UNITED STATES PATENT AND TRADEMARK OFFICE

10/573,871

Office Action Summary	Application No. 10/573,871	Applicant(s) CRONIN ET AL.	
	Examiner JAYMI DELLA	Art Unit 3739

DETAILED ACTION

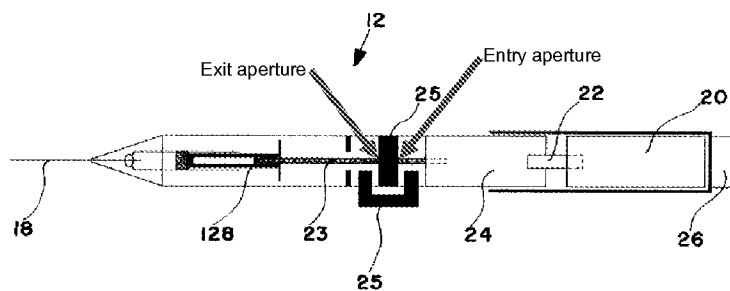
56. Concerning **claims 61-63**, Junior further discloses that the housing (25) includes at least one aperture that includes an entry aperture, through which the cable enters the housing and an exit aperture, through which the cable exits the housing, that permits **substantially** linear motion of the cable relative to the housing as illustrated in annotated Fig. 2 below.
